More reasons to object to the Flamingo Land Planning Application

The 28 day statutory minimum consultation period on the revised Flamingo Land Planning Consultation ends on Monday when Green MSP, Ross Greer, is due to hand in over 52,000 objections he has helped gather to the Loch Lomond and Trossachs National Park Authority. The LLTNPA, to its credit, has said that it will continue to accept objections after this date although it is unclear whether they will alert the public to the final closing date for objections. It is safer therefore, if you have concerns, to lodge them sooner rather than later.

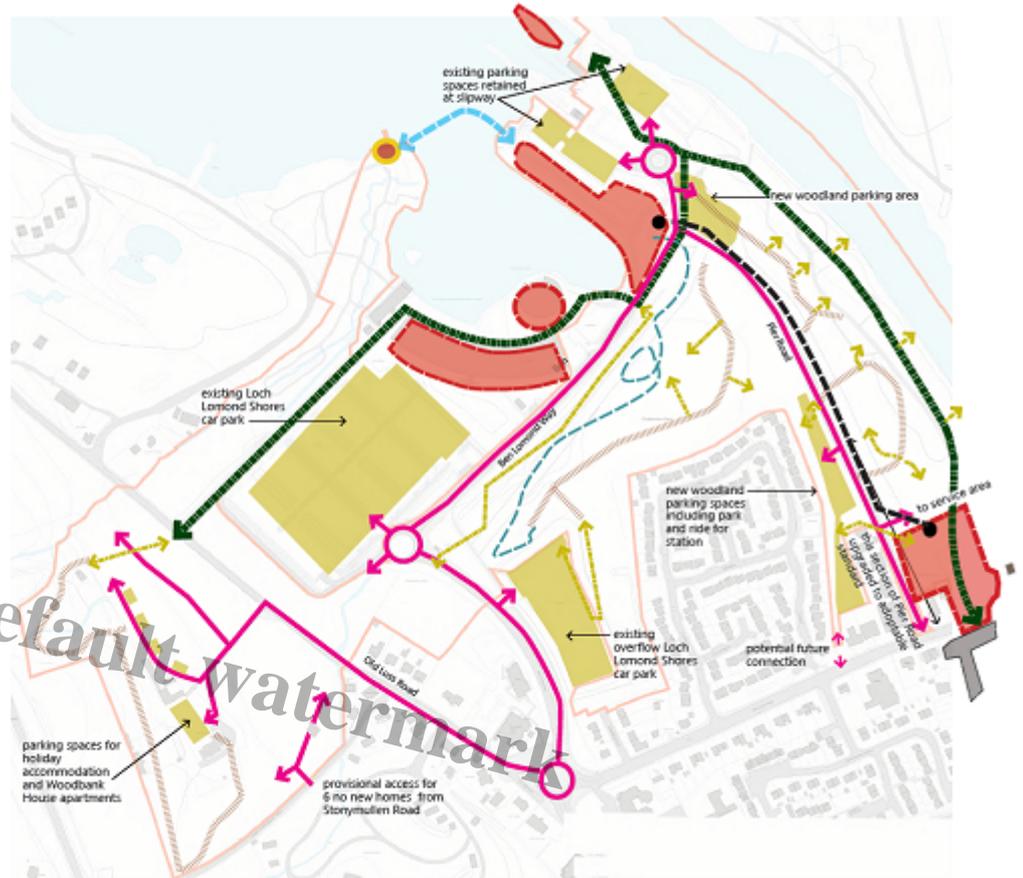
'a water main cuts across the south west corner of the Woodbank site'

Scottish Water, in their response to the application dated 30th April state the applicant needs to provide both a water and a drainage impact assessment. This is to enable them to decide whether they can provide sufficient water to the development (existing capacity is likely to be sufficient) and then carry away and treat the waste water (not known). Flamingo Land appear not to have provided this as yet. As Kenneth explains, the significant increase in the size of the proposed development at Woodbank House and the creaking existing capacity could make the whole development unviable.

The bigger issue, of course, is the capacity of the existing infrastructure to drain and then treat waste water from the site as a whole. Its amazing that the LLTNPA, which has a statutory duty to promote 'sustainable development', has not yet apparently required Flamingo Land to provide information on this, signed off by Scottish Water, BEFORE considering whether to grant Planning Permission in Principle.
